**CITY OF GRASS VALLEY
ENGINEERING DIVISION**

ADDENDUM NO. 1

**CDBG MEMORIAL PARK FACILITIES IMPROVEMENT
PROJECT, PROJECT NO. 20-05**

ADDENDUM NO. 1

DRAWN BY: **RJL** DATE: **FEB 2021**
 CHECKED BY: **BPJ** DATE: **FEB 2021**

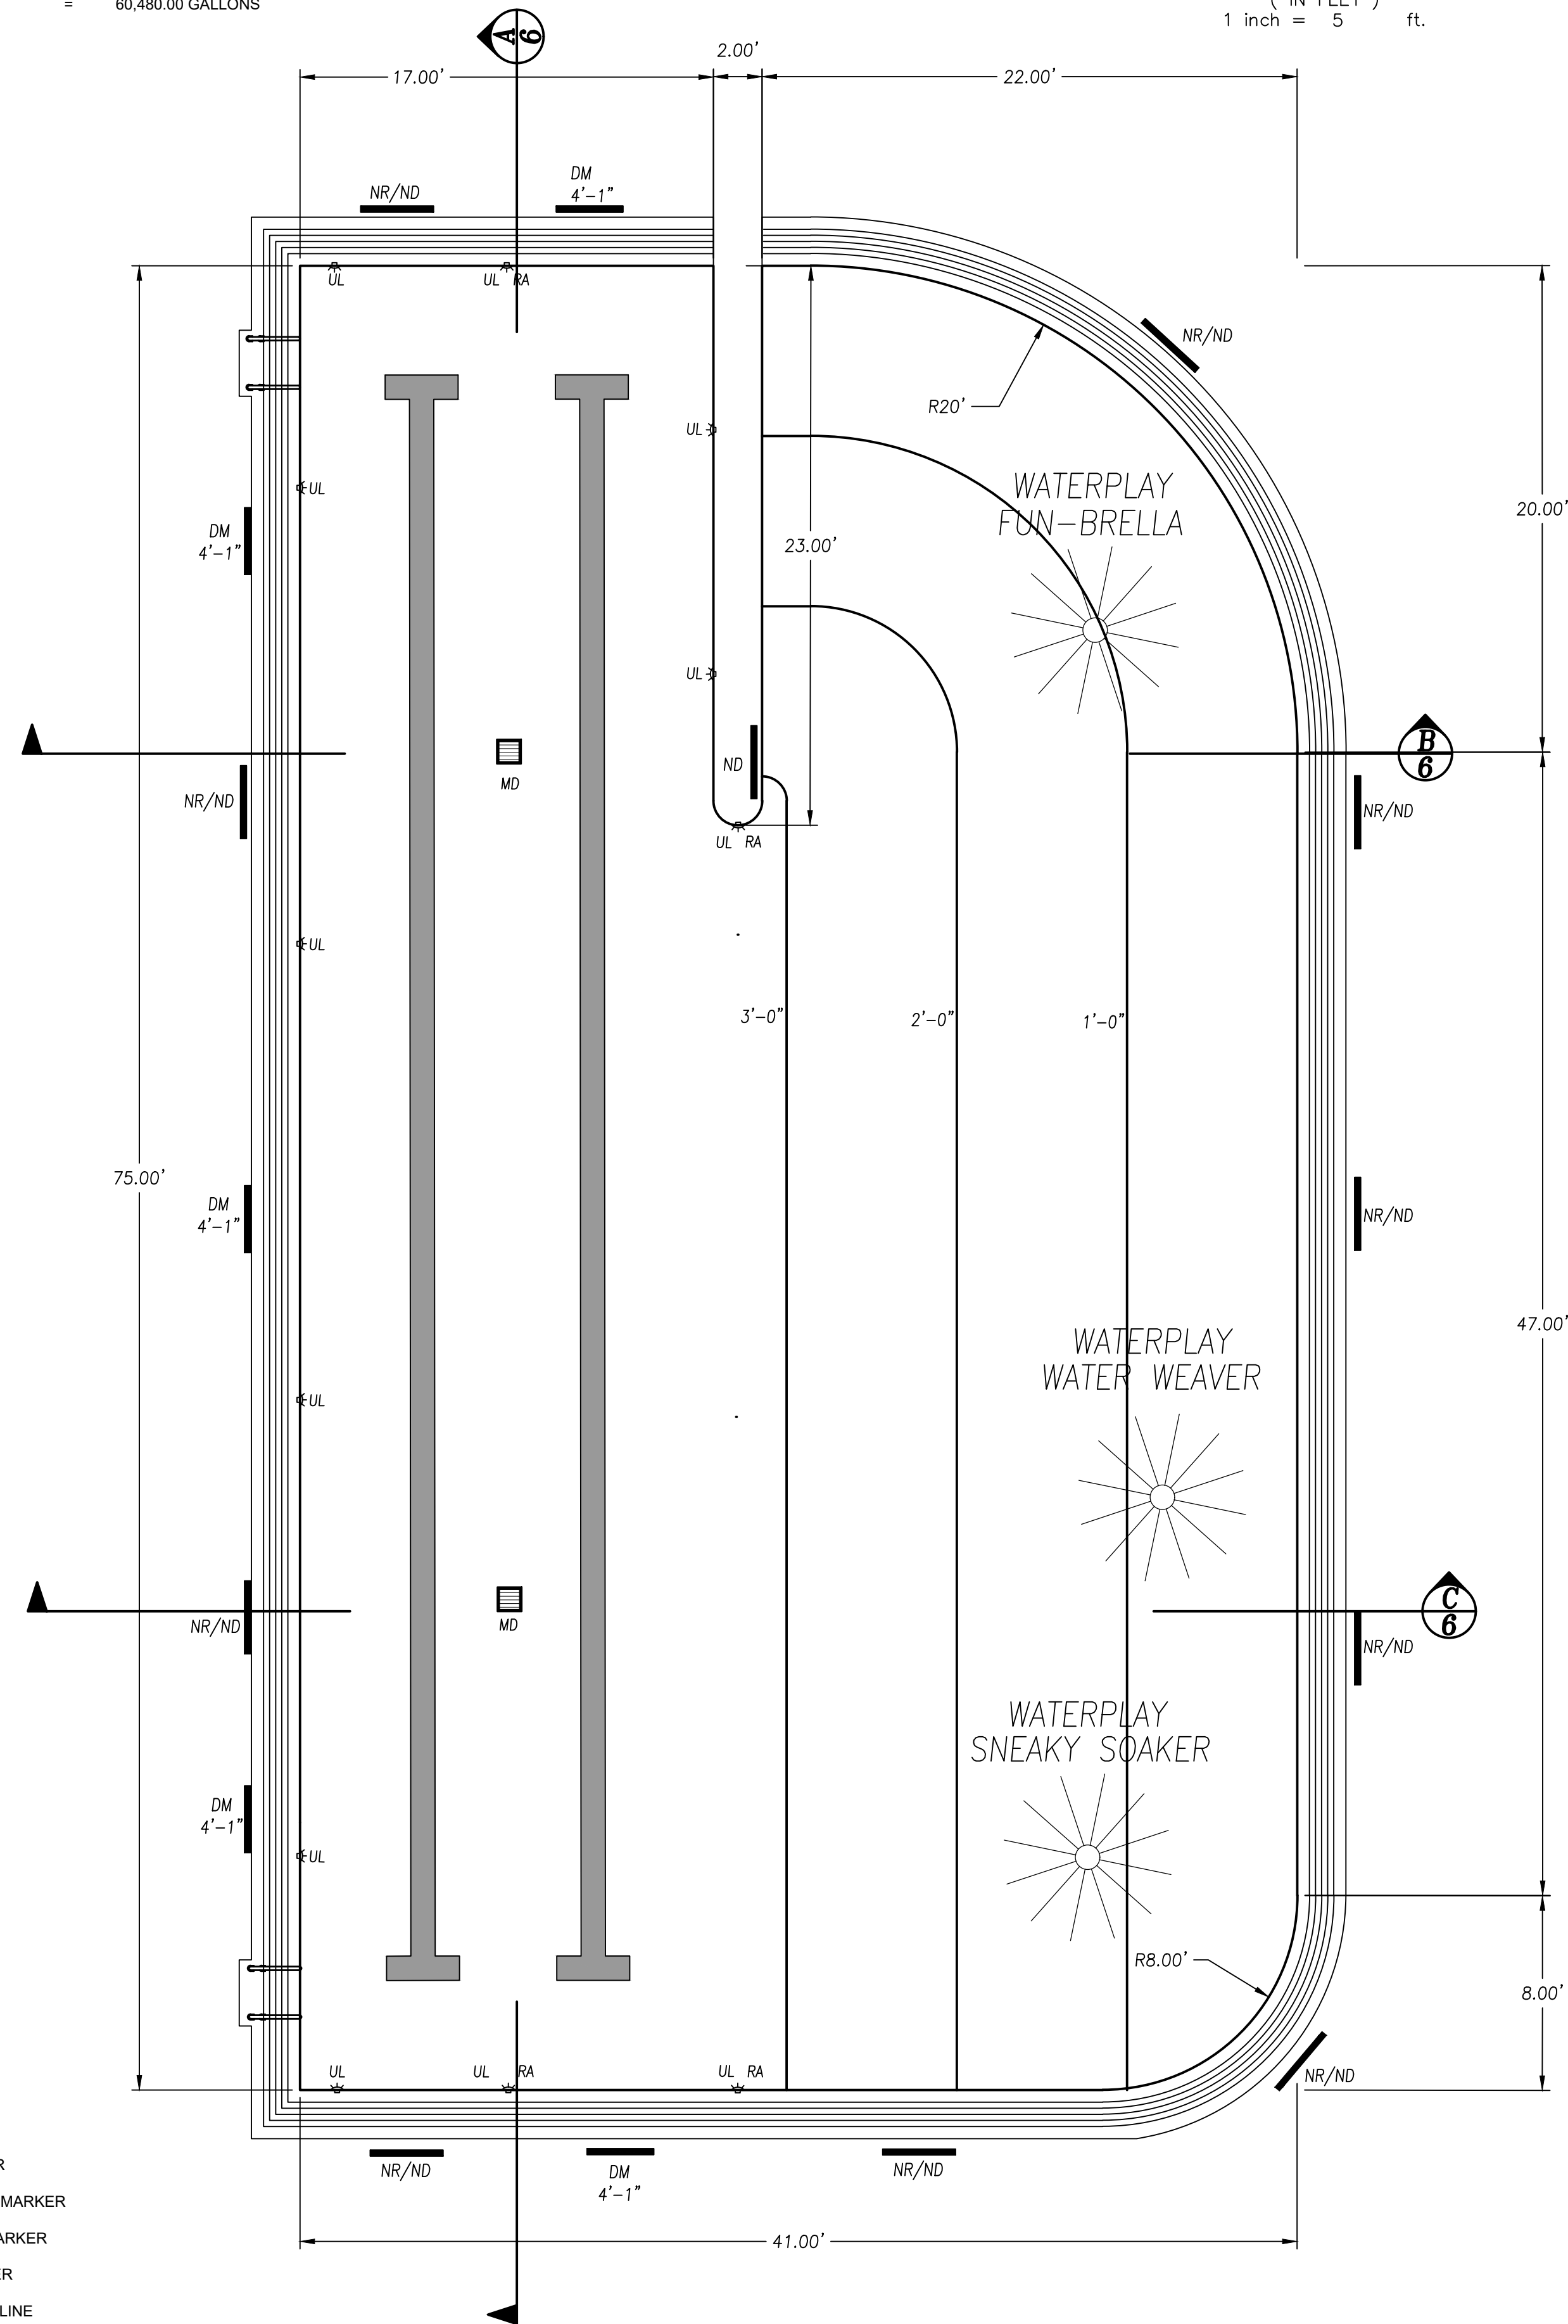
1. Sheet 1, Sheets 3 through Sheet 6, and Sheet 19. Replace the sheets in their entirety with the attached revised sheets. Remove reference to pool details. Modify the Activity Pool layout and cross sections. Move Seat Retaining Wall detail to sheet 19.
2. Sheets 7 through Sheet 9. Delete all pool details from the bid plan set.

REVISIONS		APPROVAL	Date
No.	Description	Engr Init	By
1	REV REF TO DETAILS	BPJ	3/29/21

CITY OF GRASS VALLEY ENGINEERING DIVISION
**CDBG MEMORIAL PARK FACILITIES
 IMPROVEMENT PROJECT**
ACTIVITY POOL DETAILS AND SECTIONS

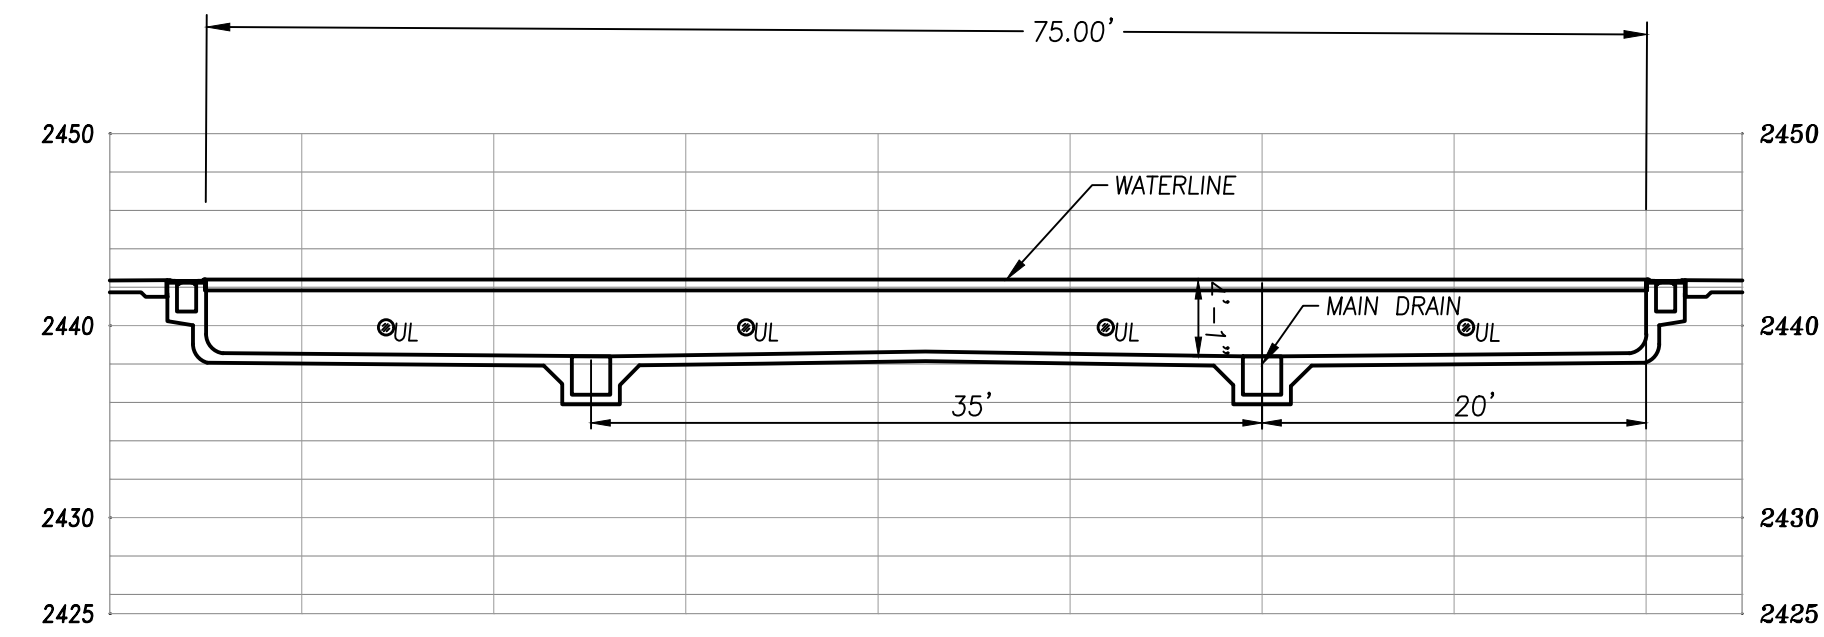
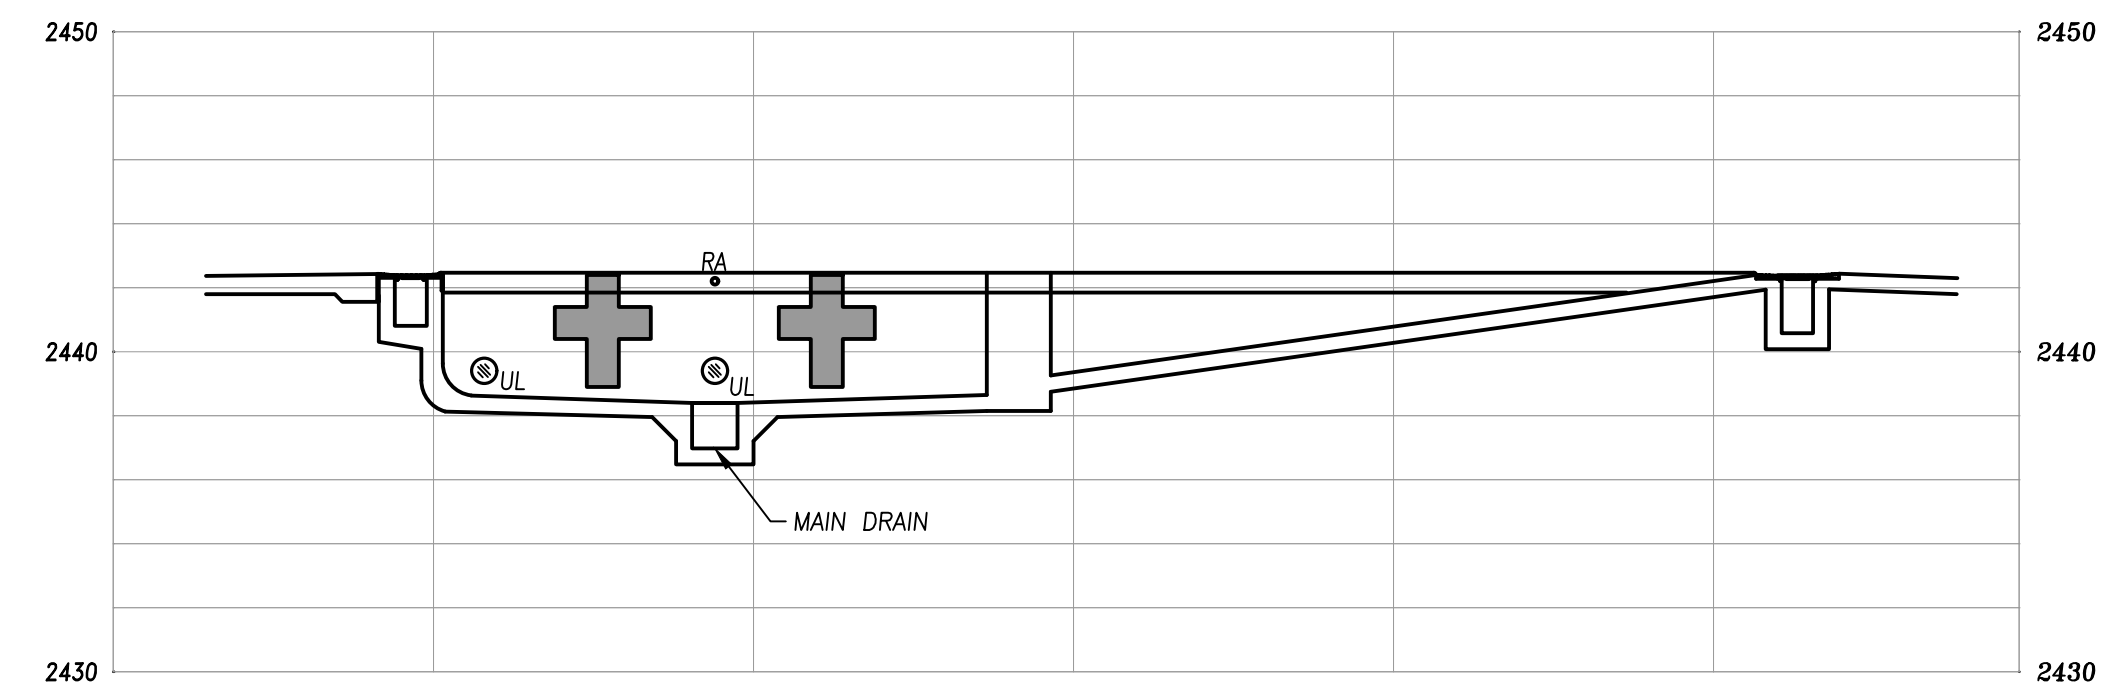
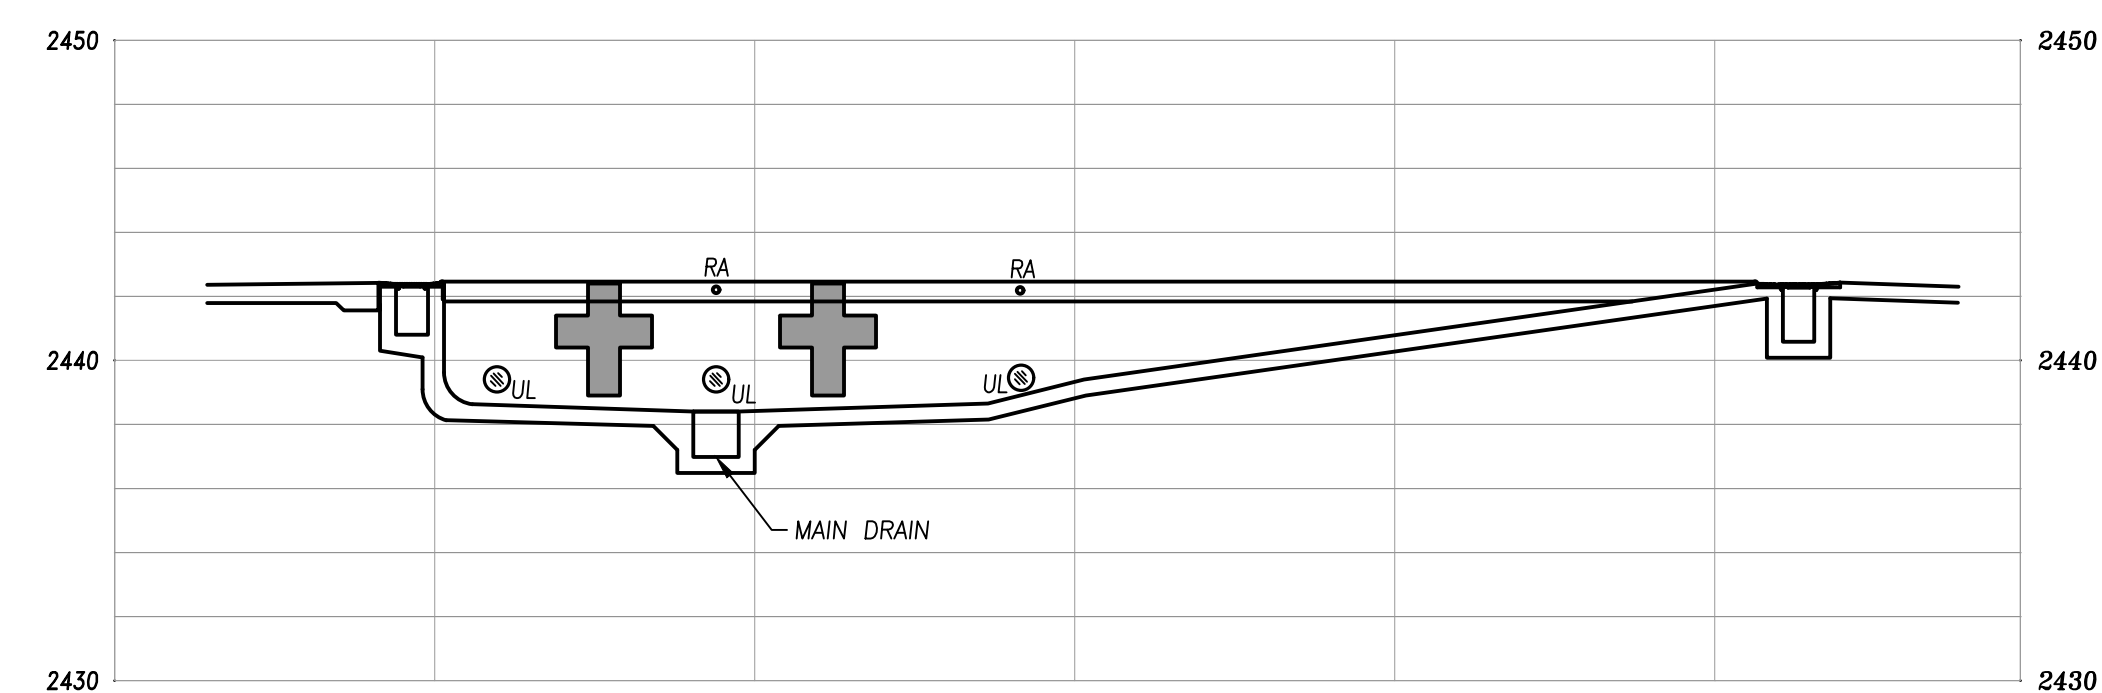
No.	Description	APPROVAL	
		Engr Init	Date
1	REVISE LAYOUT, DEPTH, R/W REF TO DETAILS	BPJ	3/29/21
